**STAFF REPORT
KETCHUM PLANNING AND ZONING COMMISSION
SPECIAL MEETING OF FEBRUARY 23rd, 2021**

PROJECT: Warm Springs Ranch

FILE NUMBERS: P 21-001, P21-002, P21-003, and P21-010

APPLICATION TYPES: Development and Rezoning Agreement, Large Block Preliminary Plat, Block 1 Subdivision Preliminary Plat, and Floodplain Development/Waterways Design Review

Height Planes and Footprints

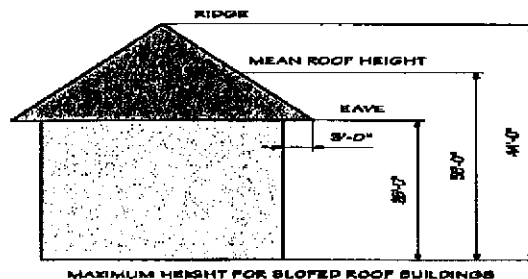
Height Plane	Tent Diagram	Scheme 11, Version 1	December 2 Resubmittal
At grade		Footprint is 119,262	132,000 square feet footprint of Core Hotel Building
Above 65 feet		43,994 sq. feet (8.3% of the bldg footprint)	
Above 70 feet	Tent Diagram allows for 25% of the Core Bldg footprint above this height		The Applicant requests to retain the maximum allowed under the Tent provisions; based on Core Hotel Bldg. = 33,000 sf.
Above 80 feet	Tent Diagram allows for 15% of the Core Bldg Footprint above this height	11,146 sq. feet (2.1% of bldg footprint) 17,900 would be allowed under the tent provisions for the Scheme 11 footprint	The Applicant requests to retain the maximum allowed under the Tent provisions; based on Core Hotel Bldg. = 19,800 sf.

CONCLUSION: The Council found the height waiver request acceptable and the Tent Diagram, Drawing A.6 shall guide the maximum height of the buildings.

The Tent diagram, Drawing A6, includes maximum roof heights of 93 feet.

L2 - Block 1 - Riparian Restoration Plan

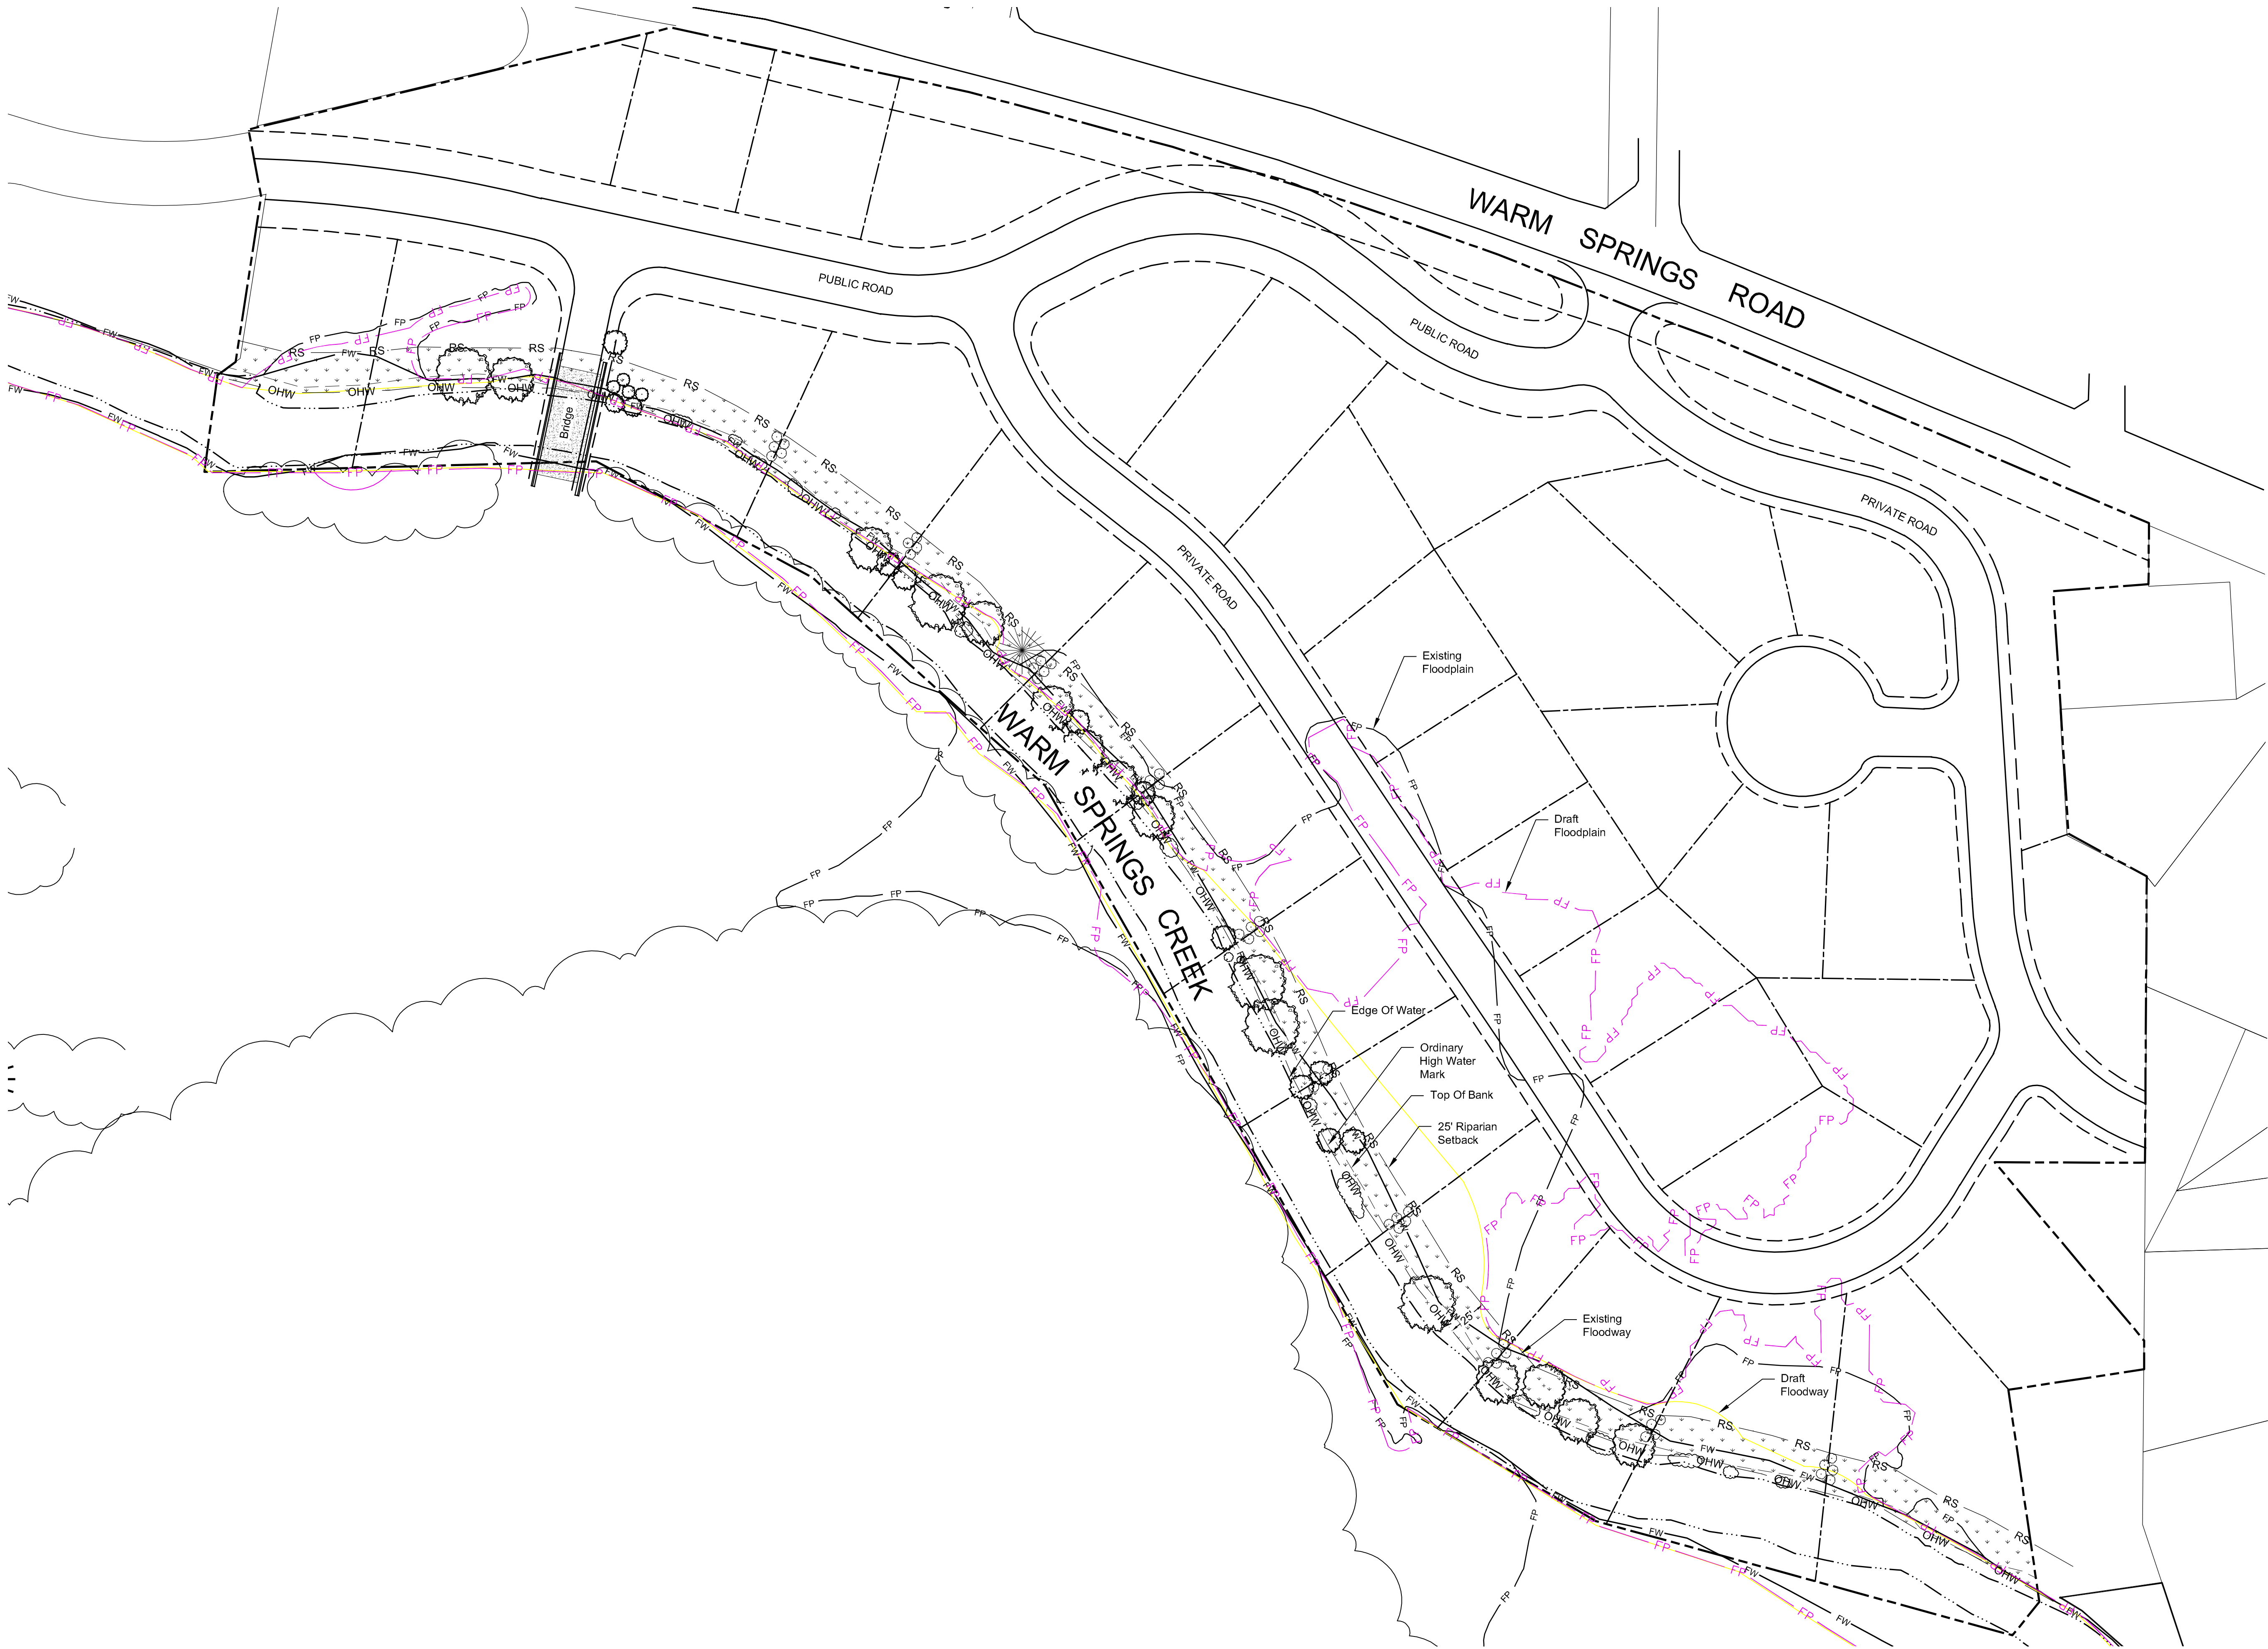
The riparian restoration plan, Sheet L2, includes the planting of 70 new 5-gallon size native shrubs (three species of willows, common snowberry, red-osier dogwood, and golden currant) and a native grass mix during the summer of 2021, the installation of temporary irrigation (for a maximum of two growing seasons) to aid in the vegetation's establishment, weed control (hand-

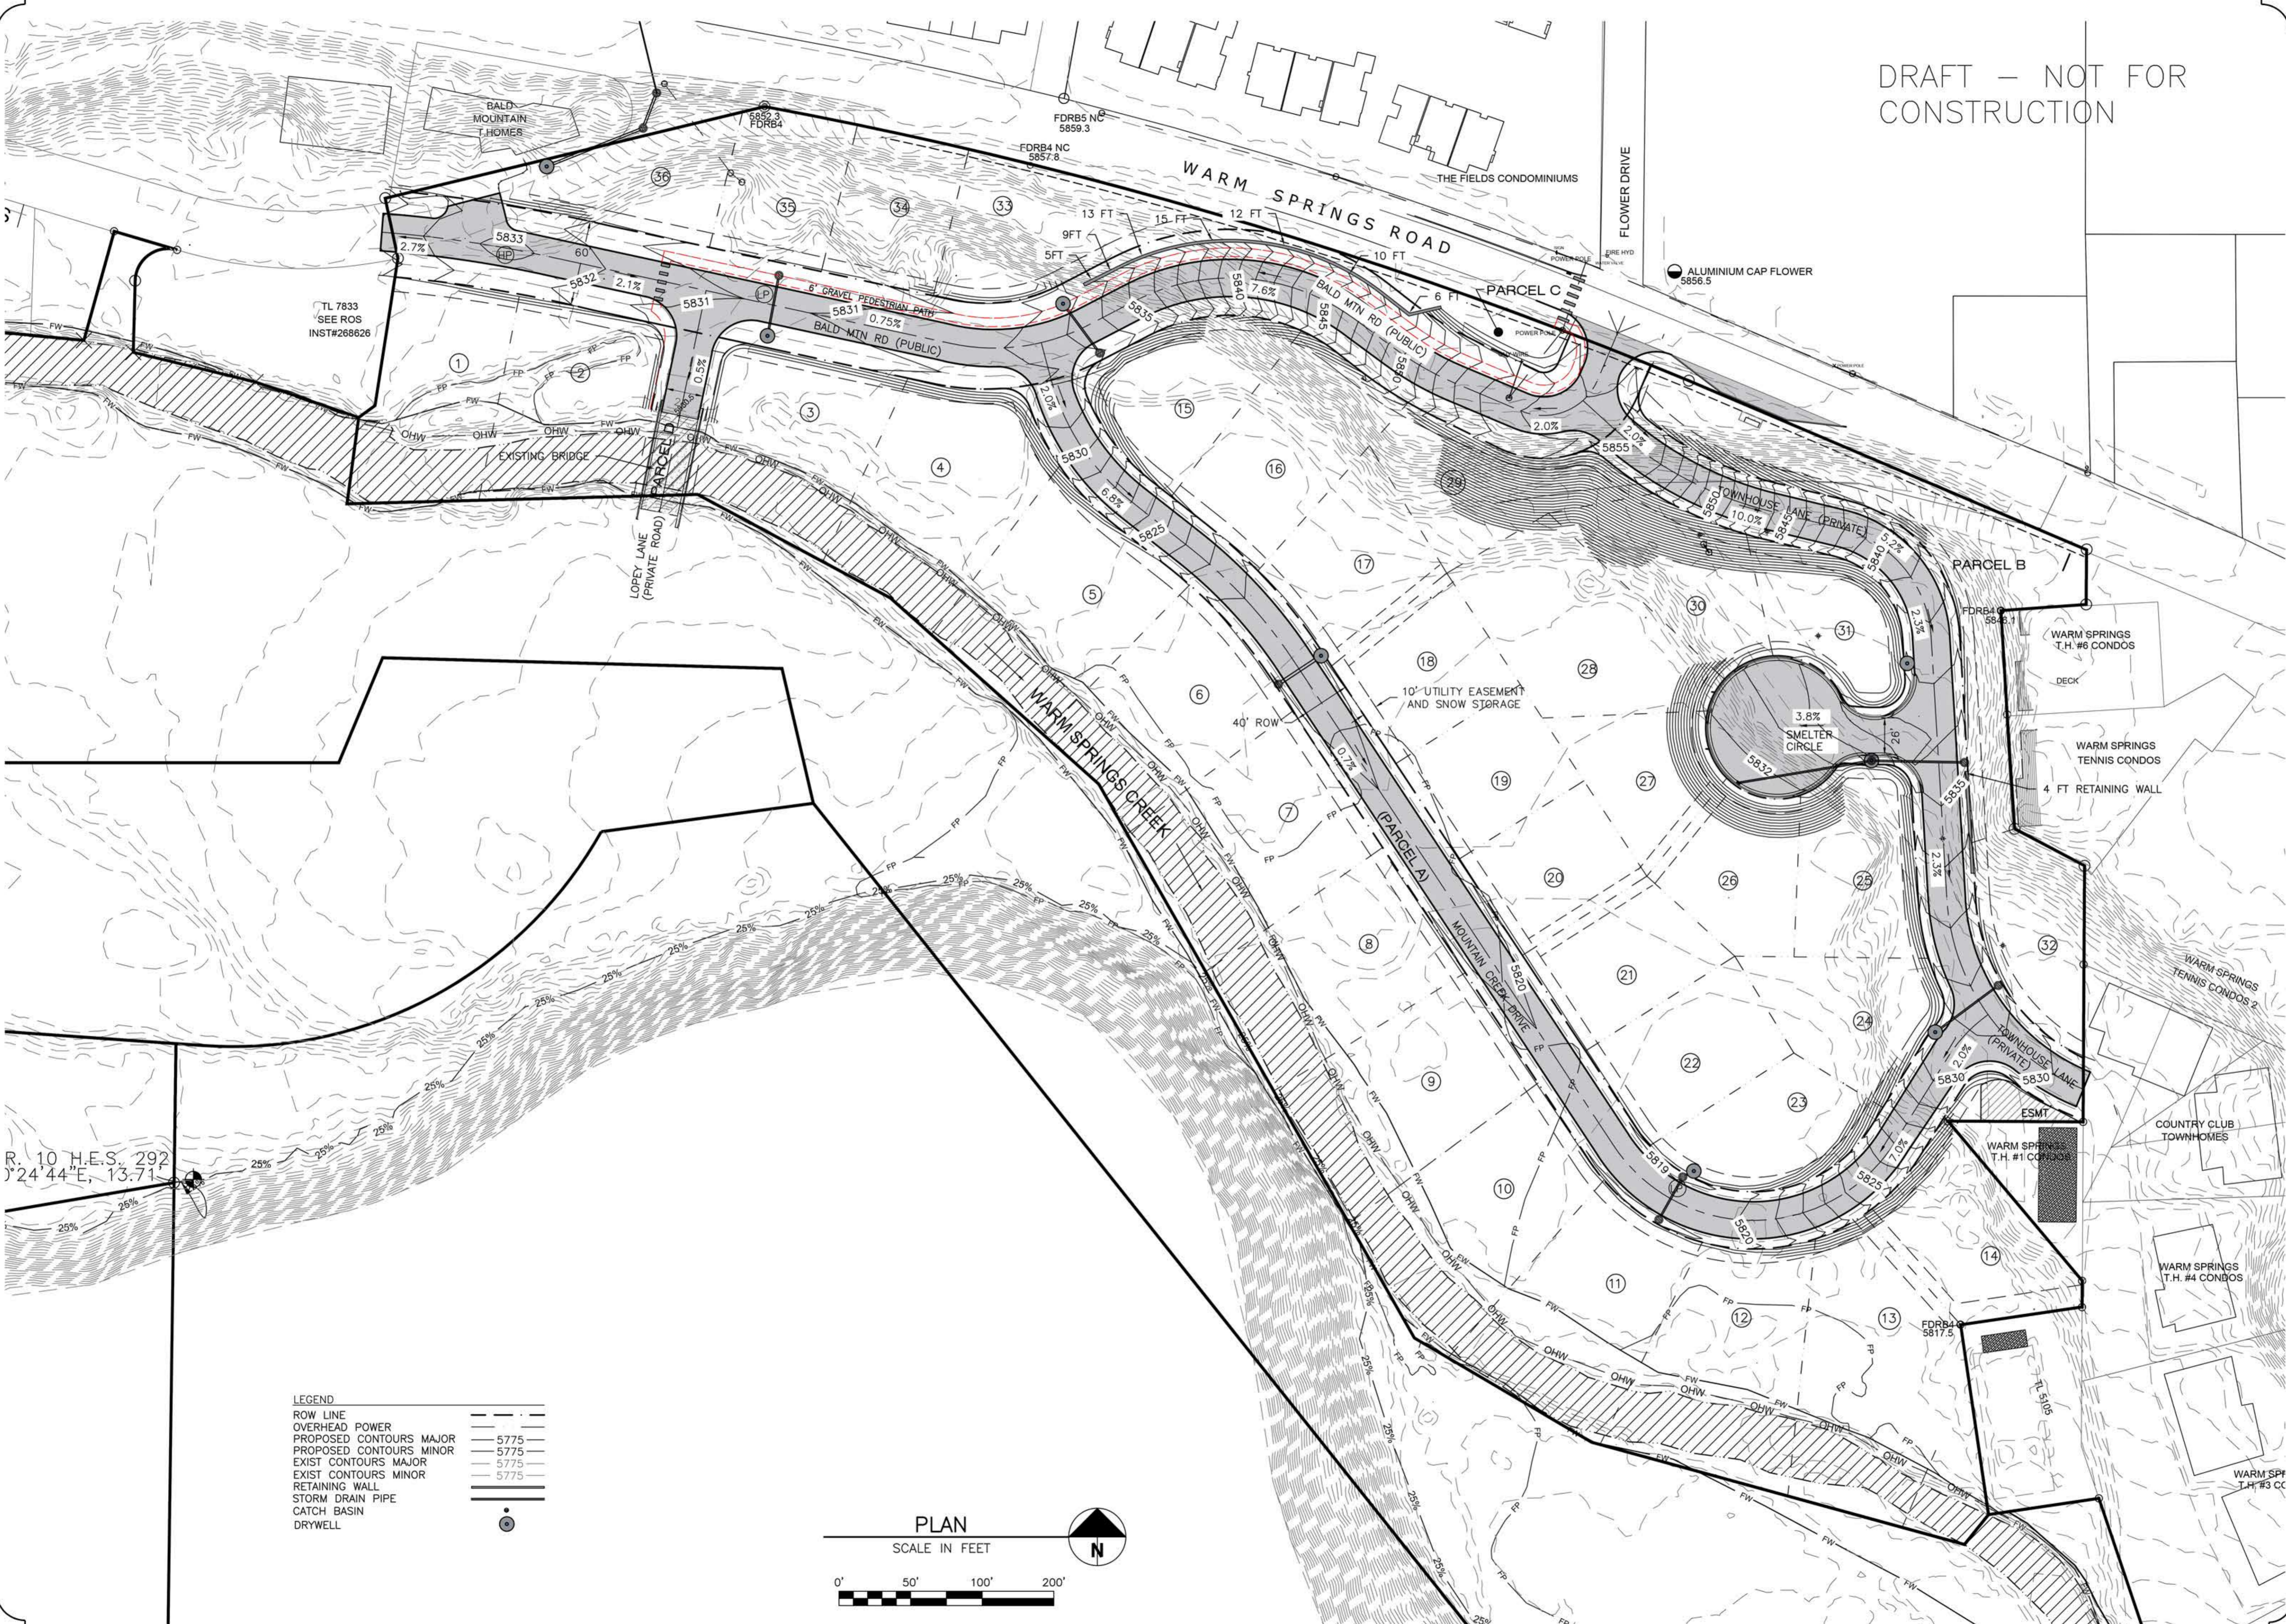
Drainage within the residential subdivision will be managed through a system of swales, catch basins, and drywells. The grading and drainage plan is indicated on Sheet C-2 of the project plans (Attachment C).

Staff Comments	<i>The grading and drainage plan is indicated on Sheet C-2 of the project plans. The proposed drainage plan is a system of drywells, catch basins, and storm drain pipes.</i>
<input checked="" type="checkbox"/>	<input type="checkbox"/>	<input type="checkbox"/>	16.04.030.J.15	Vicinity map drawn to approximate scale showing the location of the proposed subdivision in reference to existing and/or proposed arterials and collector streets.
			Staff Comments	<i>An area map showing Warm Springs Ranch Block 1 in relation to Warm Springs Road and existing Bald Mountain Road is included in the project plans.</i>
<input checked="" type="checkbox"/>	<input type="checkbox"/>	<input type="checkbox"/>	16.04.030.J.16	The boundaries of the floodplain, floodway and avalanche overlay district shall also be clearly delineated and marked on the preliminary plat or a note provided if the entire project is in the floodplain, floodway or avalanche overlay district.

Staff Comments	<p><i>Drainage within the residential subdivision will be managed through a system of swales, catch basins, and drywells. The grading and drainage plan is indicated on Sheet C-2 of the project plans.</i></p>
<input checked="" type="checkbox"/>	<input type="checkbox"/>	<input type="checkbox"/>	16.04.040.P	<p>P. Utilities: In addition to the terms mentioned in this section, all utilities including, but not limited to, electricity, natural gas, telephone and cable services shall be installed underground as a required improvement by the subdivider. Adequate provision for expansion of such services within the subdivision or to adjacent lands including installation of conduit pipe across and underneath streets shall be installed by the subdivider prior to construction of street improvements.</p>
			Staff Comments	<p><i>The applicant must coordinate with Idaho Power and Intermountain Gas to determine the location for all underground lines and connections. All utilities including, but not limited to, electricity, natural gas, telephone and cables services shall be installed underground. Adequate provision for expansion of such services within the subdivision or to adjacent lands, including installation of conduit pipe across and underneath streets, shall be installed by the subdivider prior to construction of street improvements. (Ketchum Municipal Code §16.04.040.P).</i></p>
